**Meeting of the Central Valley Flood Protection Board  
July 27, 2012  
Staff Report – Encroachment Permit  
Sacramento Area Flood Control Agency (SAFCA)  
Unionhouse Creek Improvements, Sacramento County**

Consider approval of Permit No. 18777

The applicant proposes to widen the existing concrete-lined bottom of Unionhouse Creek by 8-feet from Franklin Boulevard to Center Parkway; and to concrete line the side slopes of Unionhouse Creek from Center Parkway to Bruceville Road; and relocate an existing City of Sacramento sump pump (Sump No. 201).

**WOOD RODGERS**  
DEVELOPING INNOVATIVE DESIGN SOLUTIONS  
3301 C Street, Bldg. 100-B Tel: 916.341.7760  
Sacramento, CA 95816 Fax: 916.341.7767

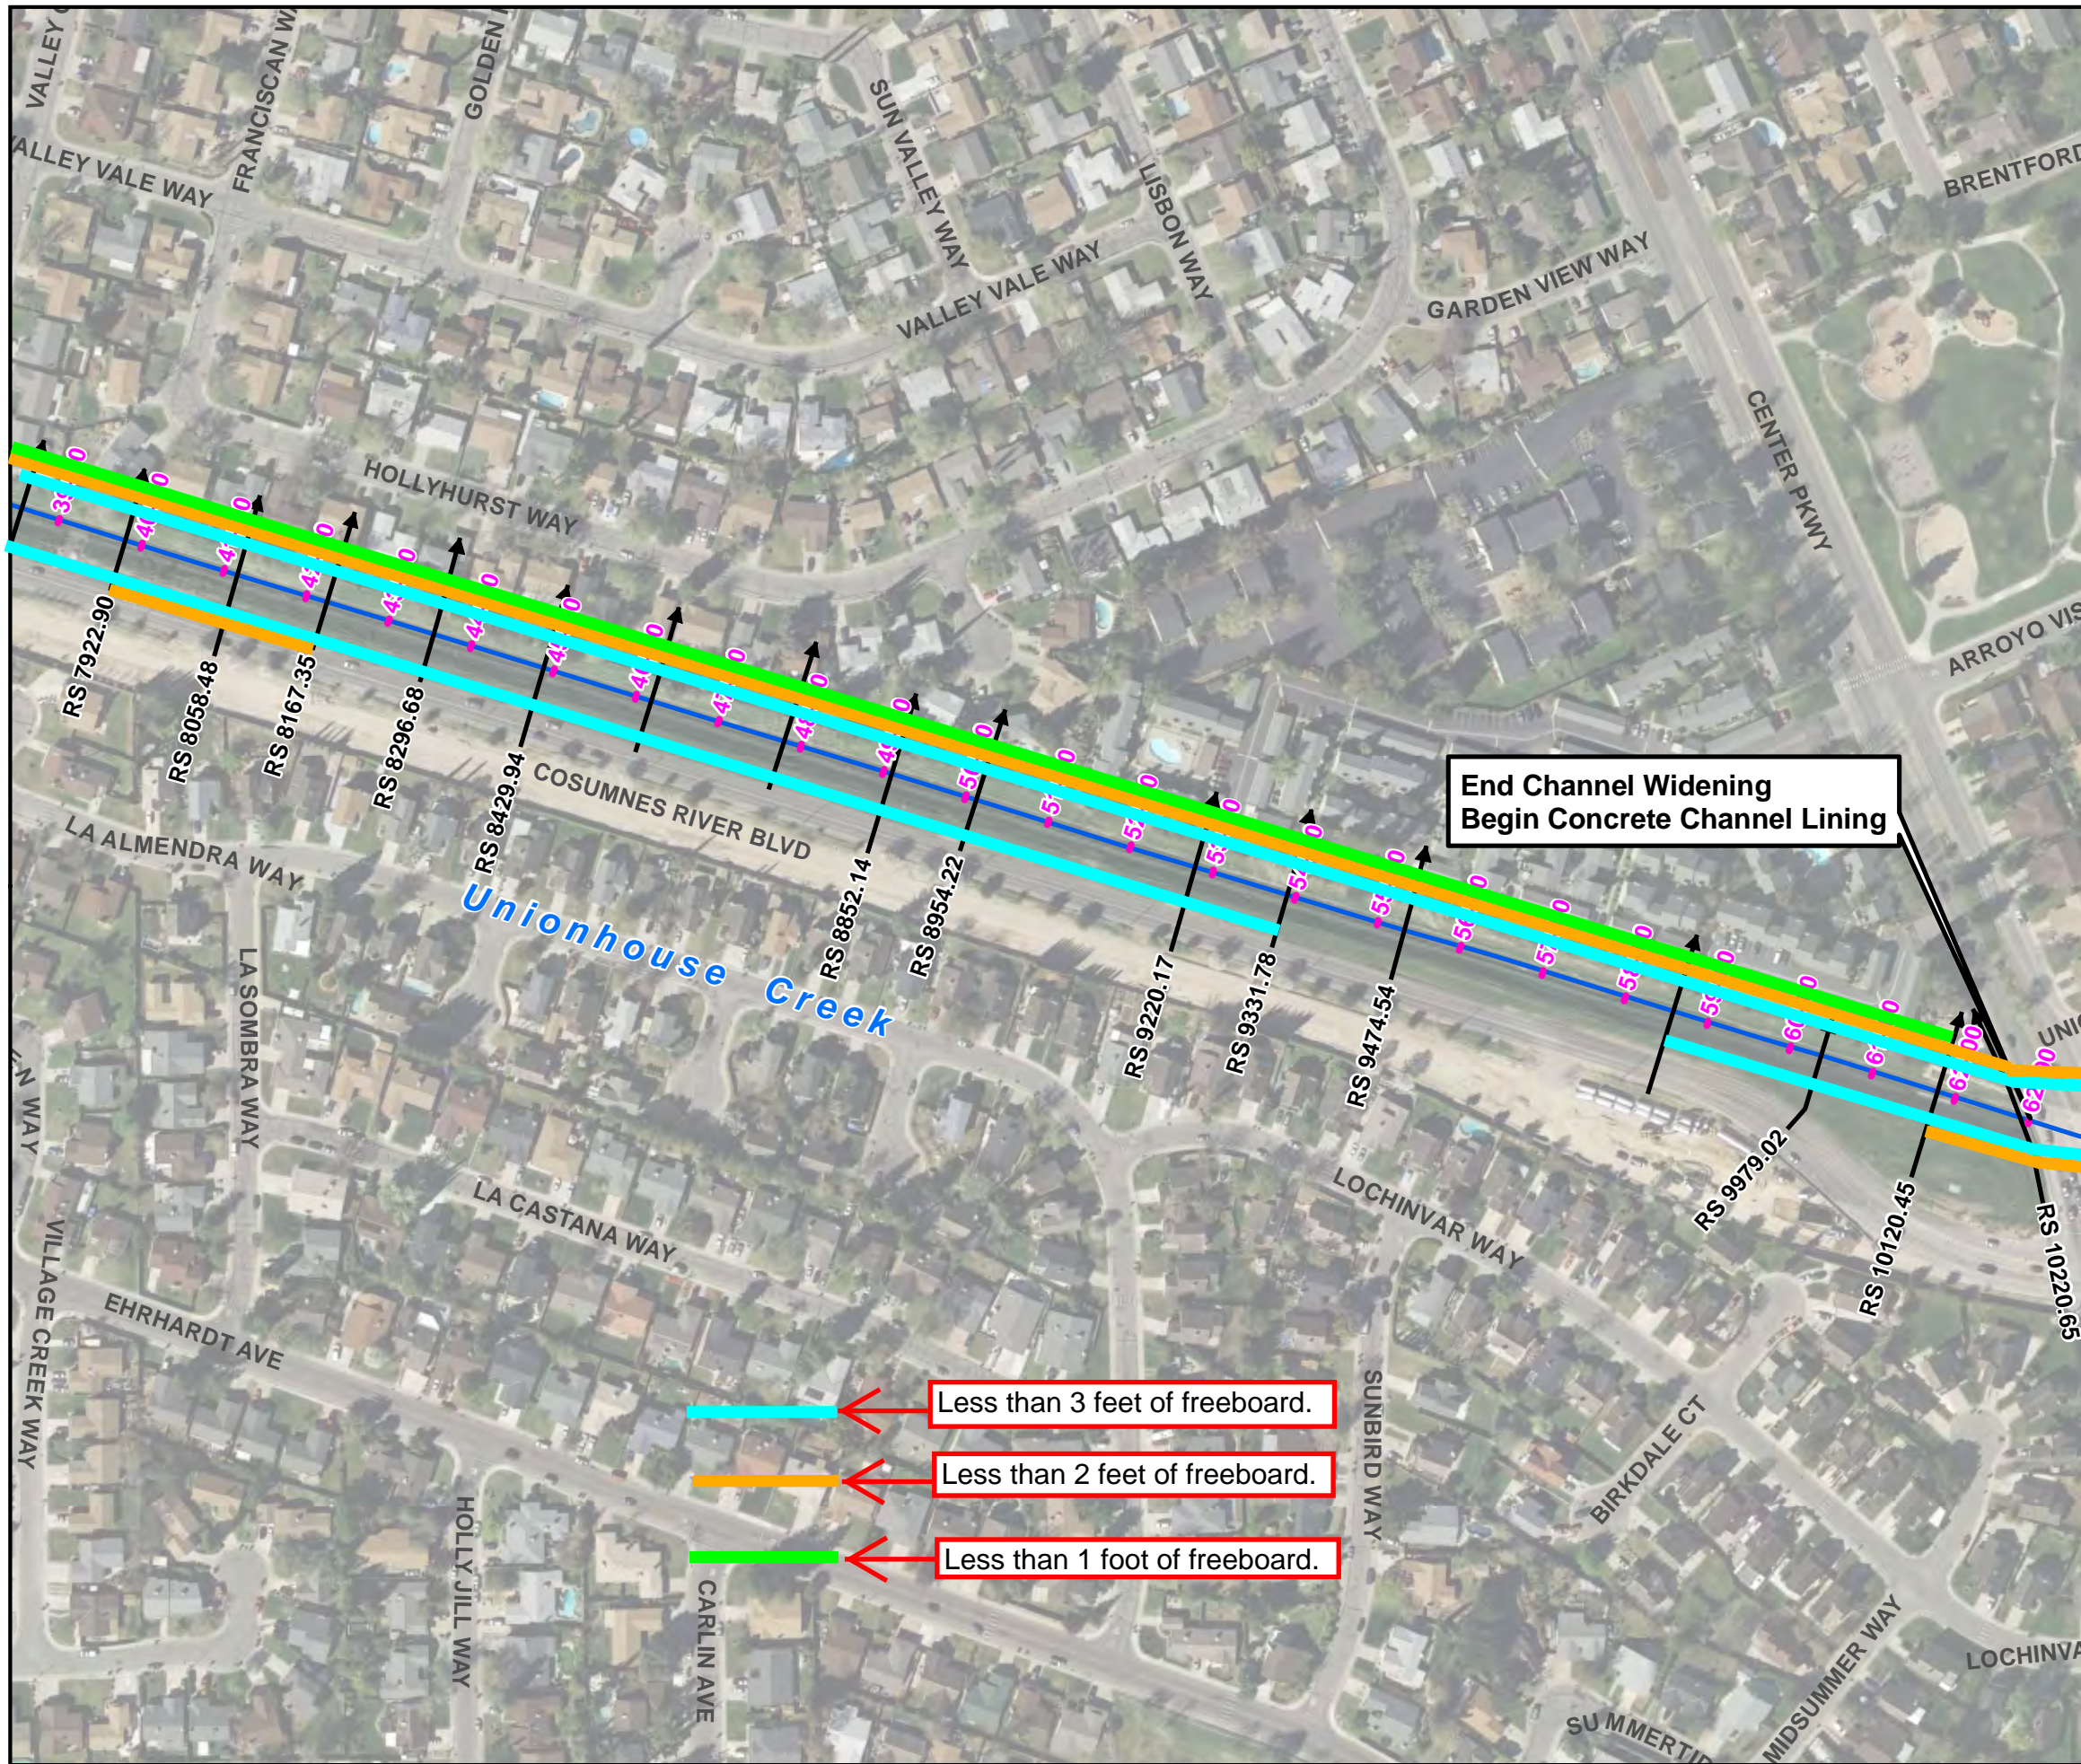
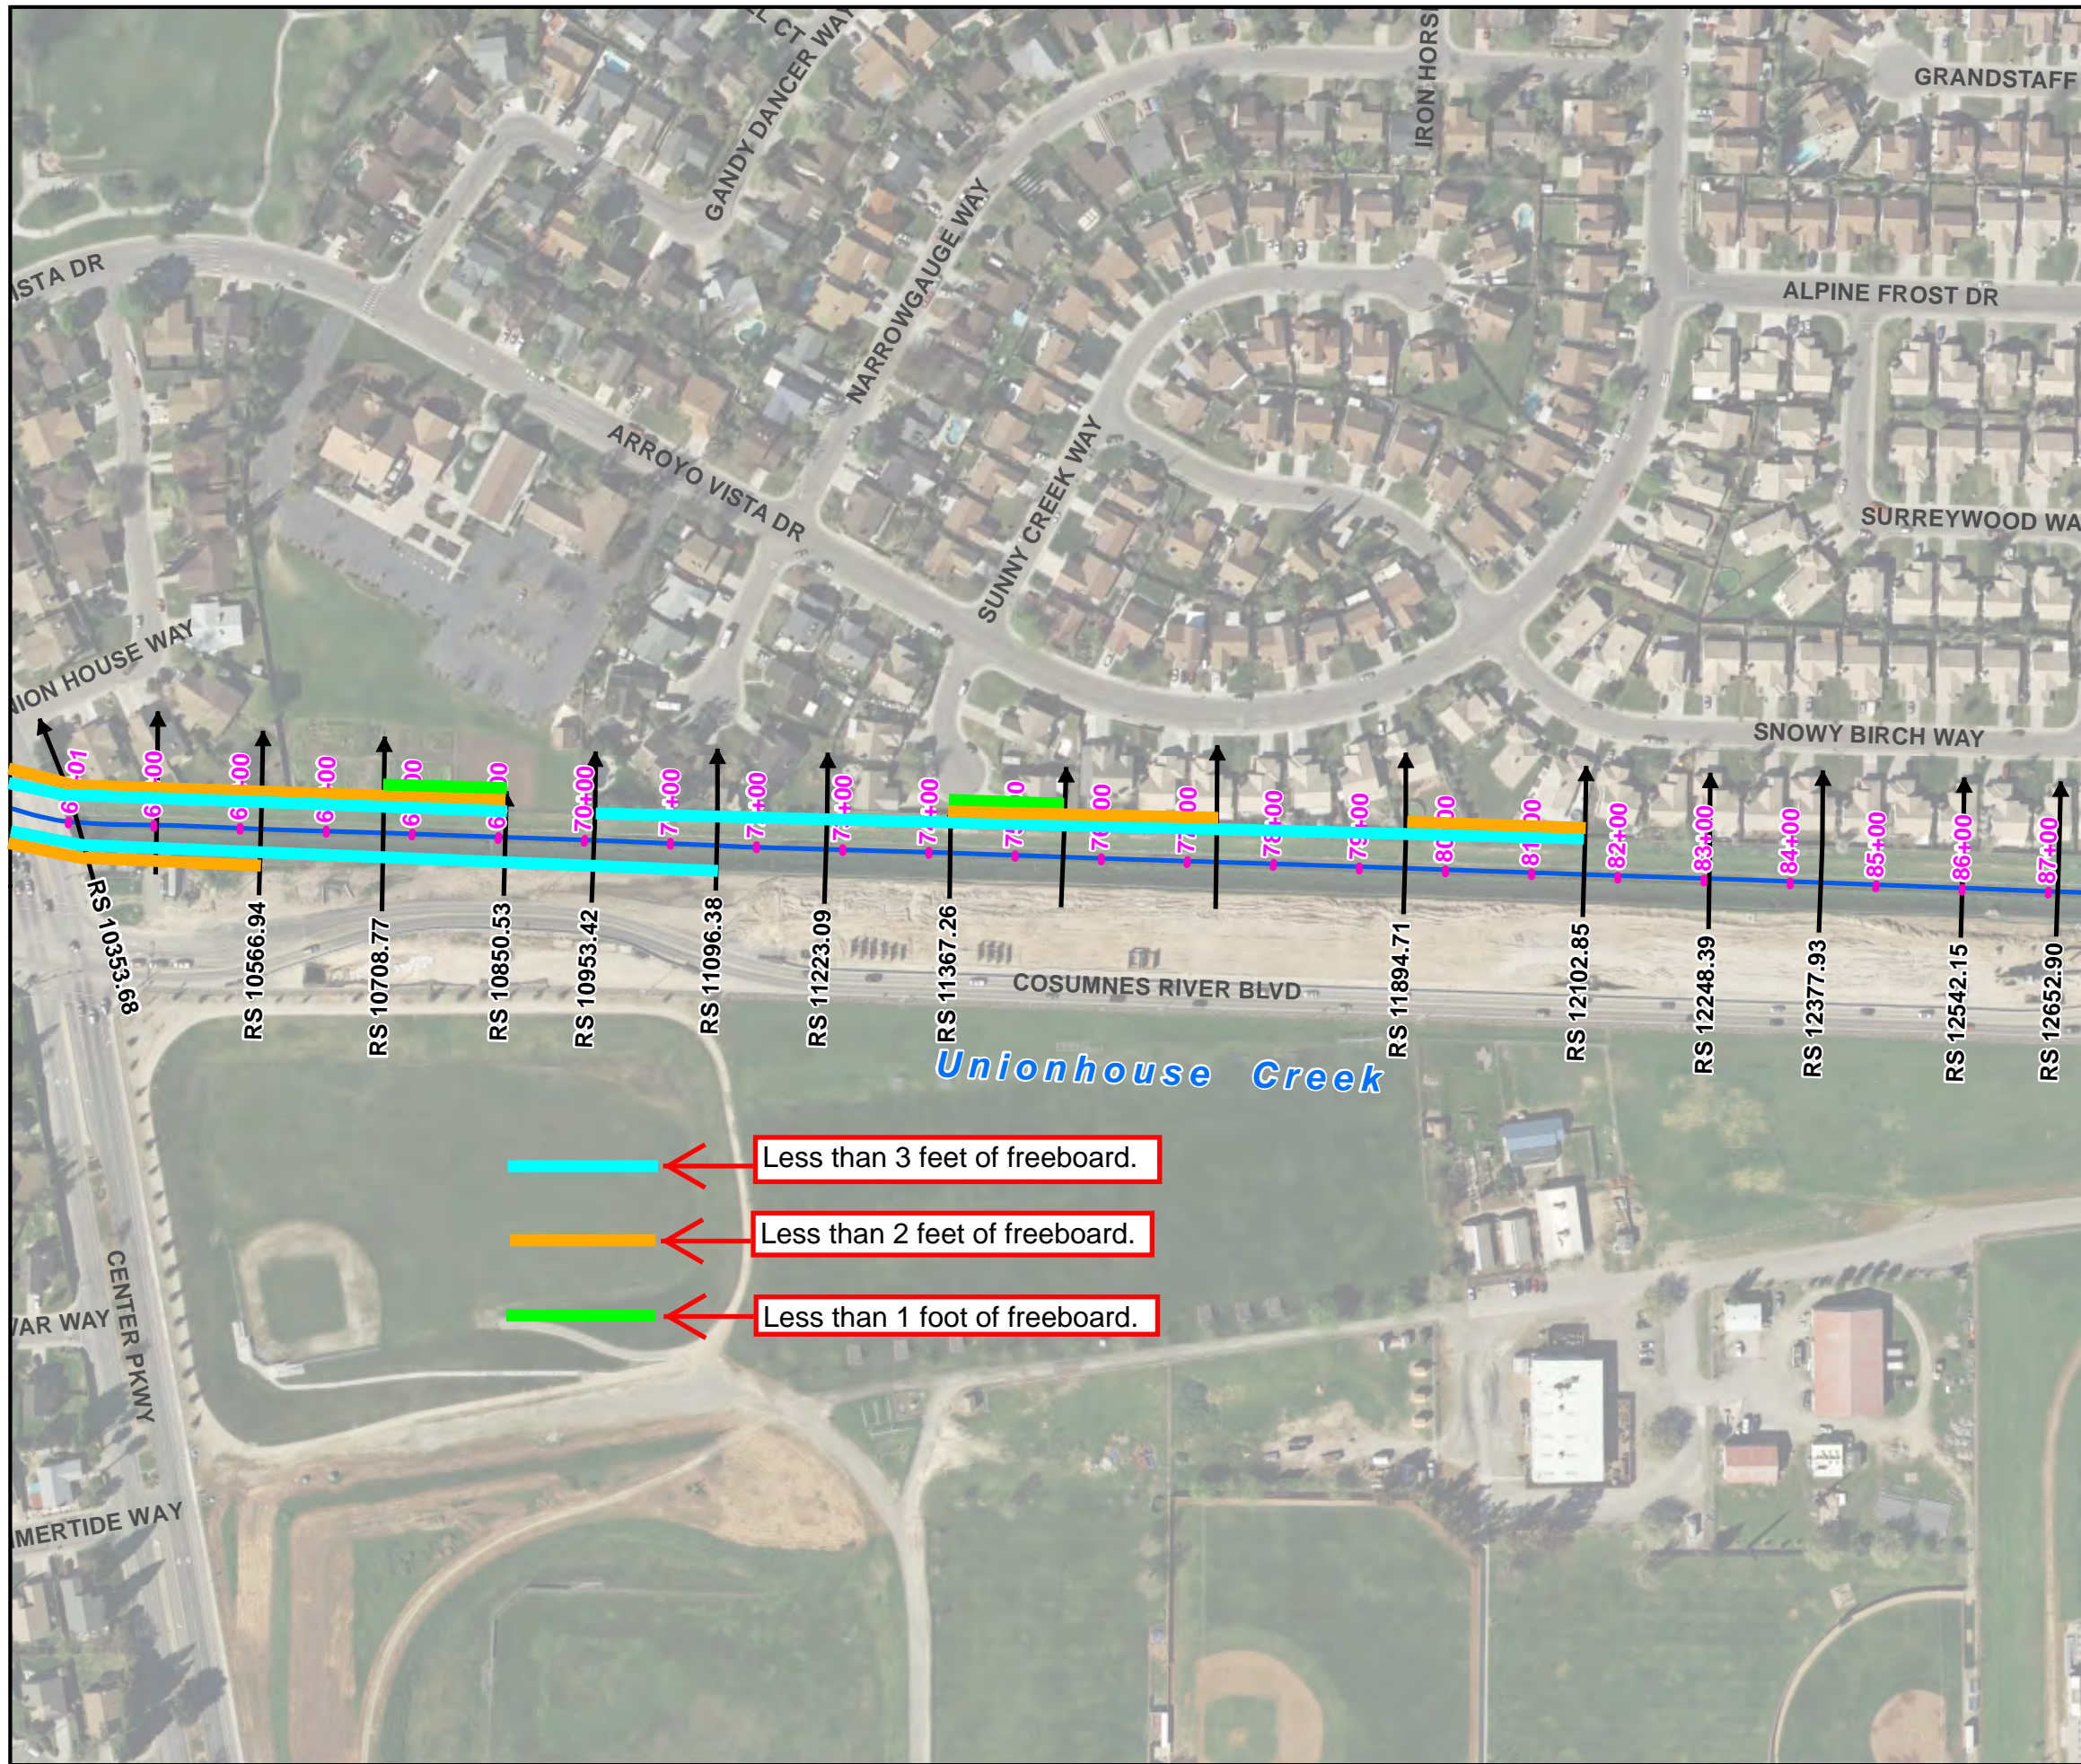
A hydraulic analysis was conducted by Wood Rodgers (WR) in May 2012 to evaluate the design proposed by SAFCA and demonstrate that the 100-year water surface elevation (WSE) would be contained in the new channel conveyance. However, the HEC-RAS model developed by WR did not include any improvements as part of the RT light rail project next to Unionhouse Creek in the analysis. CVFPB staff requested WR to re-run the HEC-RAS model considering the proposed RT light rail improvements and received an updated hydraulic report from WR on July 9, 2012. The results concluded that the proposed RT improvements would elevate the 100-year and 200-year WSE for the existing Unionhouse Creek configuration, noting that with RT's embankment above the 100-year WSE, southerly Unionhouse Creek overland release would no longer flow to Consumnes River Boulevard when additional channel capacity is needed. As a result, both peak flows and WSE's will increase and potentially flow north towards residential development. However, when WR ran the HEC-RAS model including a widened and improved Unionhouse Creek as proposed by SAFCA, the model indicated adequate capacity to contain the 100-year flow, and 200-year flow, with a limited amount freeboard. This limited freeboard is less than 3 feet, 2 feet and 1 foot in many locations, and in some locations it is negative. Attachment C shows the Unionhouse Creek hydraulic profile, cross sections, cross section details, detailed calculated freeboard table, aerial photo graphical freeboard representation and the FEMA 100-year floodplain for this area.

- c. CVFPB staff concludes that a safety factor (i.e.: freeboard) should be incorporated into this project in the near future, because CVFPB staff also concluded that 37% of the proposed project, as currently designed, provides less than 1 foot of freeboard for the adjacent property owners, calculated as follows:
